Customer Service Bulletin Commercial Business Group

SAFETY ALERT

Greensmaster® 500, 800, 1000, 1600

Subject: Damaged Fuel Gauge Gasket may cause fuel leak.

Figure 1

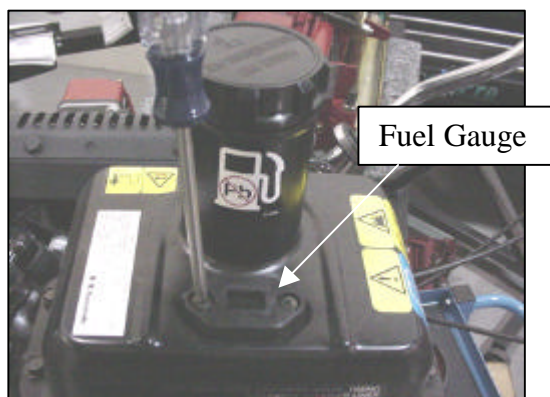
The Fuel Gauge Gasket may have been damaged when installed which may result in fuel seeping around the gauge assembly.

1. Drain all fuel from the fuel tank.
2. Remove the 2 screws that hold the fuel gauge to the fuel tank (Figure 1).
3. Replace the gasket on the fuel gauge (Figure 2).
4. Lubricate the screw threads with oil and install the screws into the gauge and gasket assembly.
5. Install the gauge assembly into the tank.

For FE120D-DS02 engines with serial numbers lower than FE120D101505 and FE120G-DS00 engines with serial numbers lower than FE120G97068, position the float to the right when inserting the gauge back into the tank. All others are positioned to the left.

6. Tighten the retaining screws to 30 in-lb. (3.4 Nm).
